AGENDA
TECHNICAL REVIEW COMMITTEE
AUGUST 7, 2018
10:00AM

WESTMINSTER PINE RIDGE ROADWAY & UTILITY DEVELOPMENT CONSTRUCTION PLANS CITY OF FRUITLAND PARK, FLORIDA

**CITY OF FRUITLAND PARK
STAFF REPORT BY LPG URBAN & REGIONAL PLANNERS, INC.**

PROJECT NO.	16-043
SCALE	NOTED
DATE	AUGUST 2017
SHEET NO.	C-15
SHEET 15	OF 18

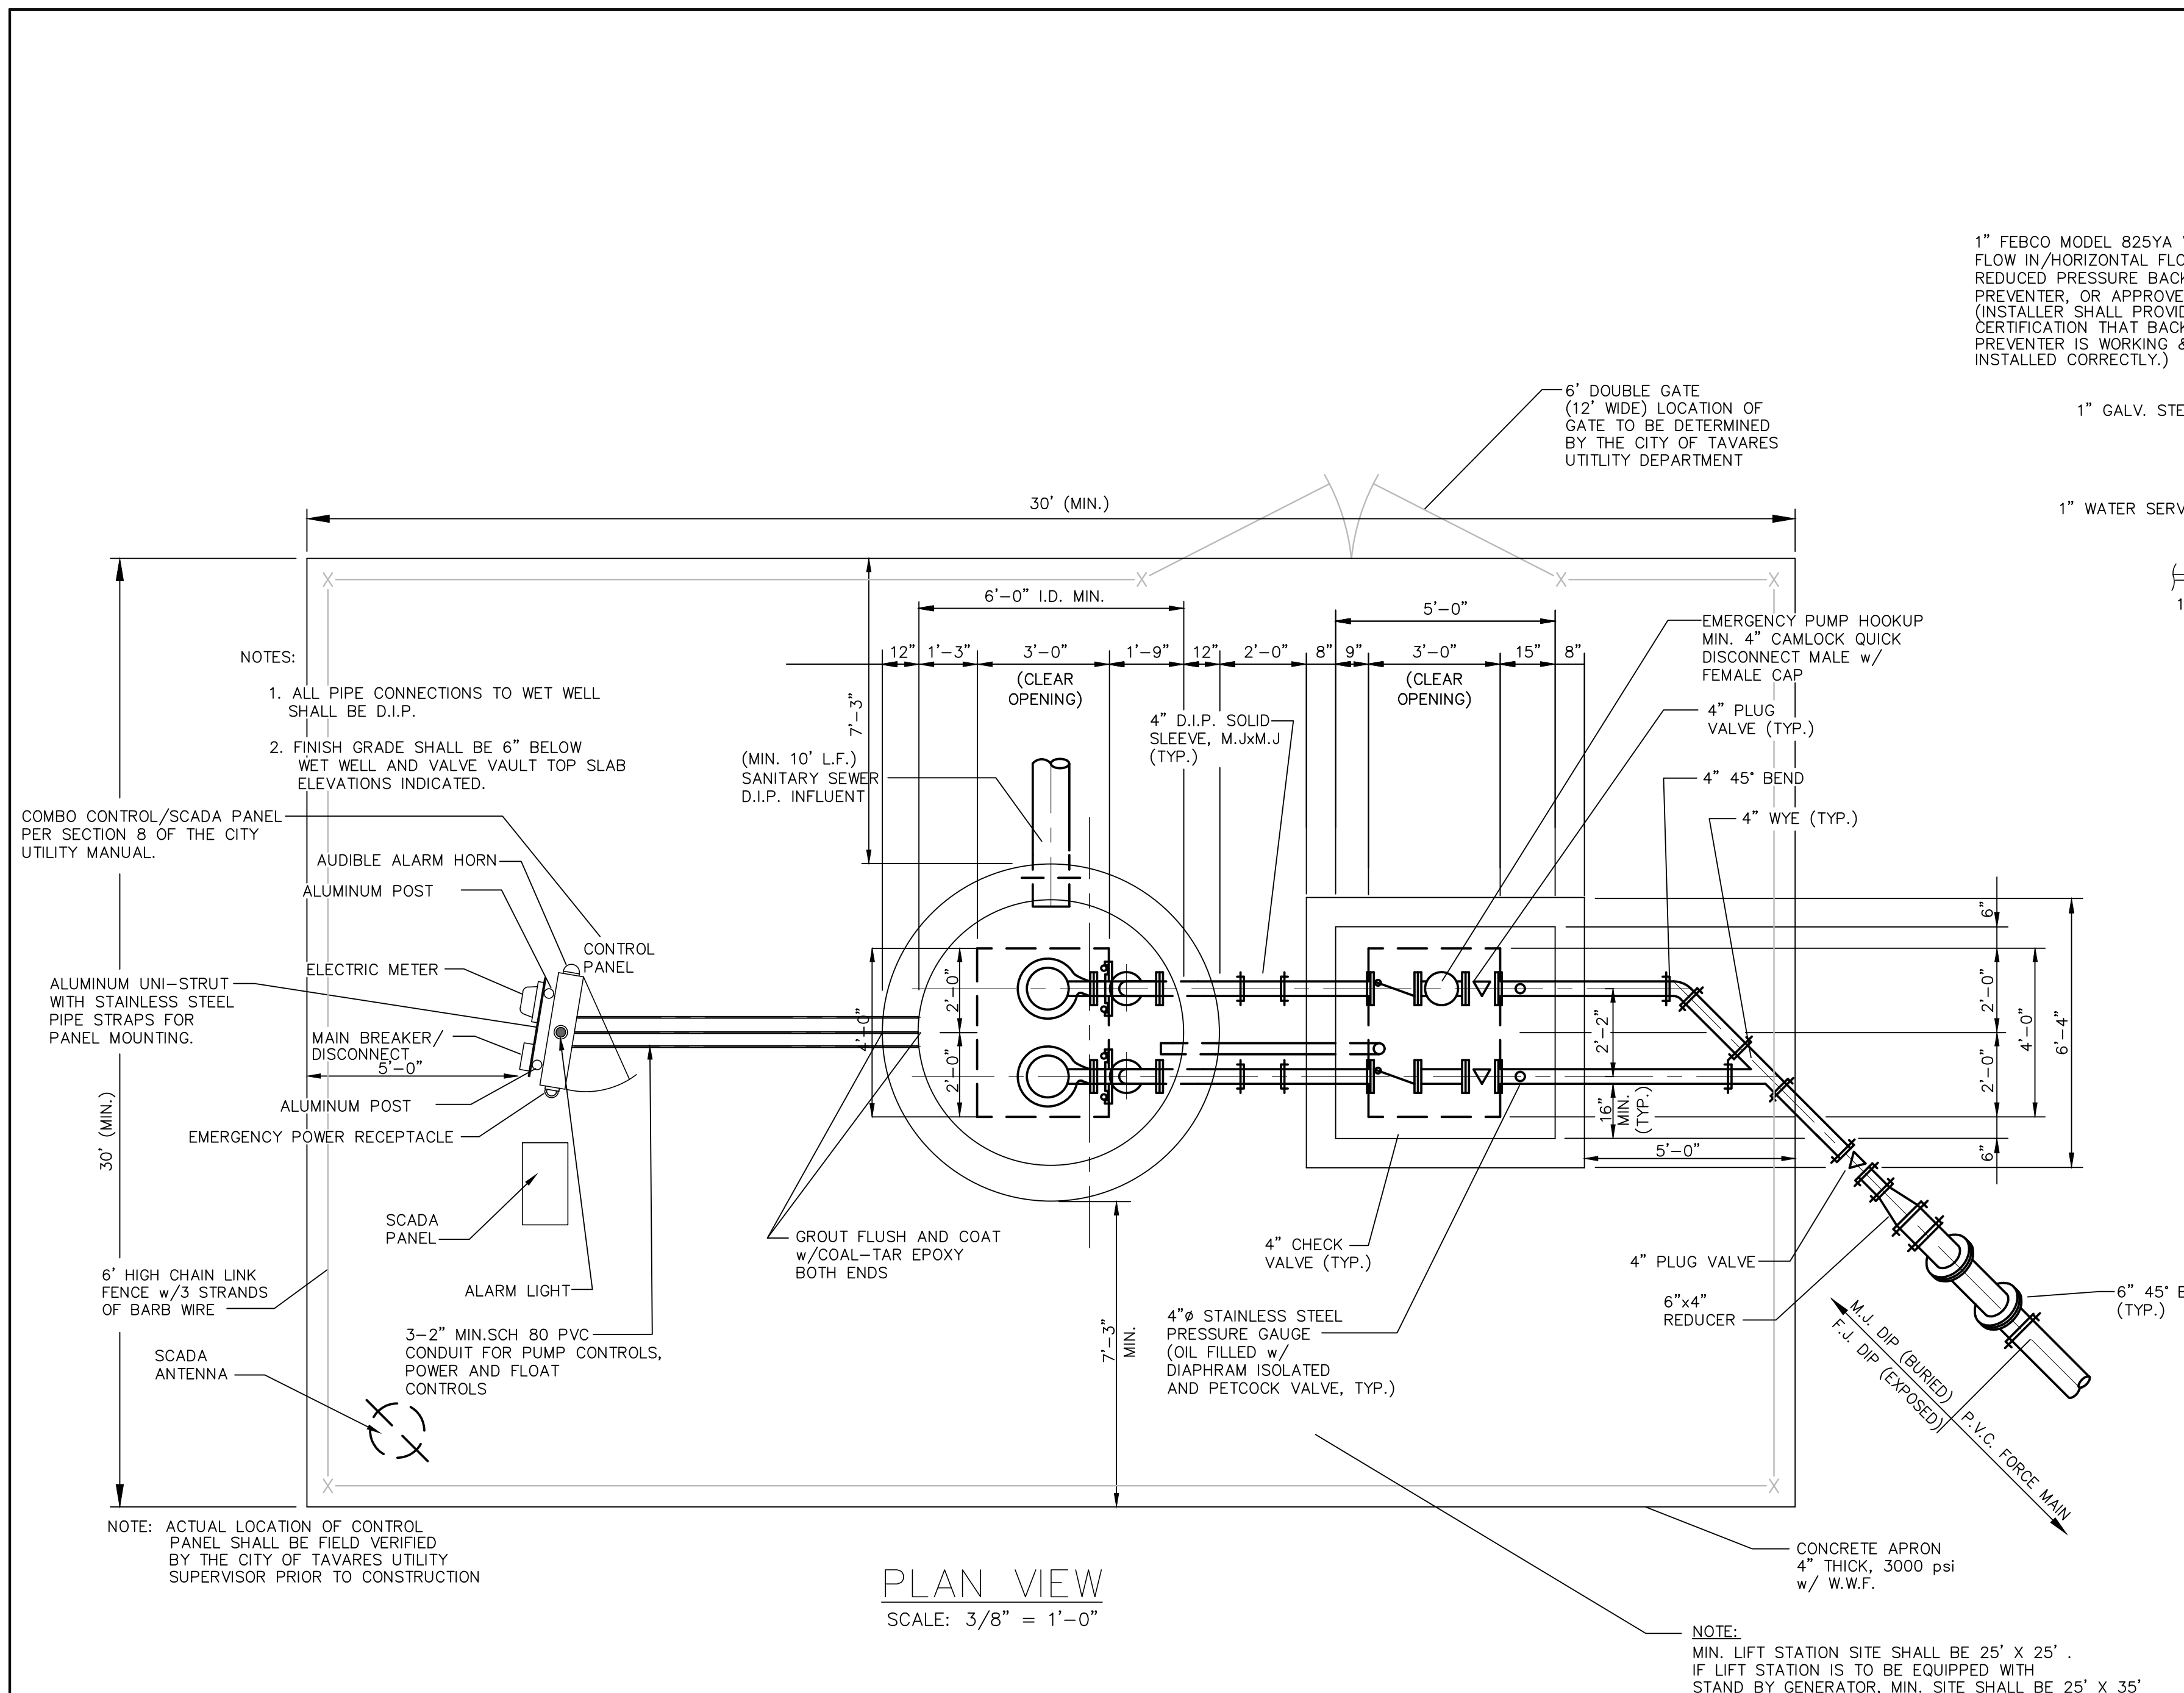
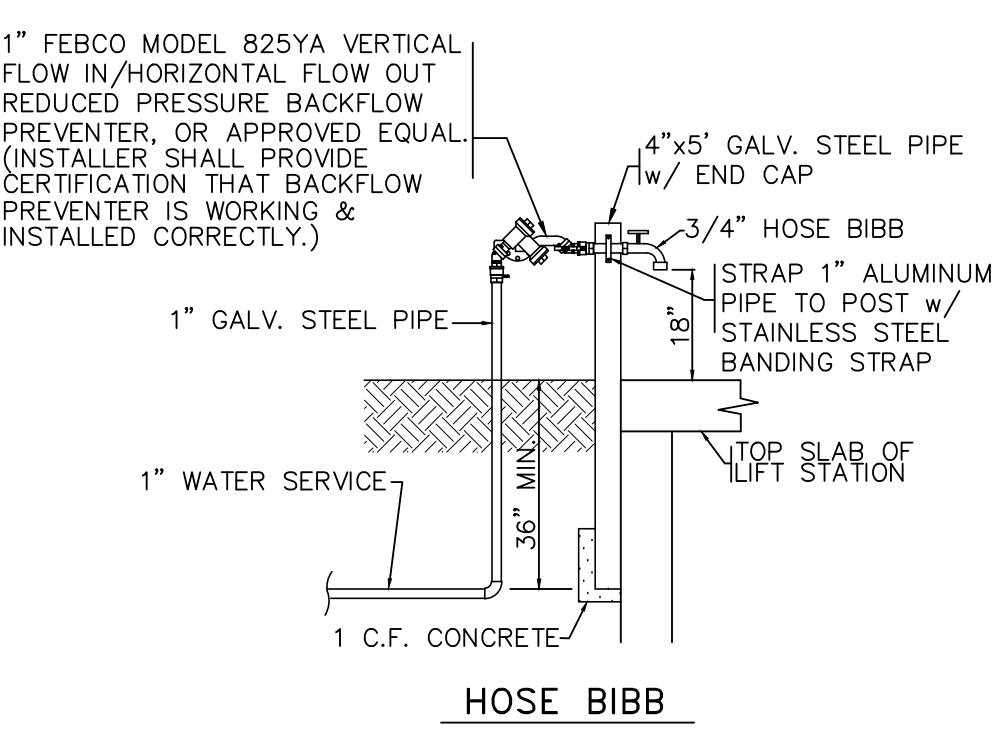
12. Sheet C-10 and C-11 – Add a note that proposed utilities and lift station are to be privately owned.
13. Sheet C-15 – The plans callout a 2" water service, but a 1" water service is shown.
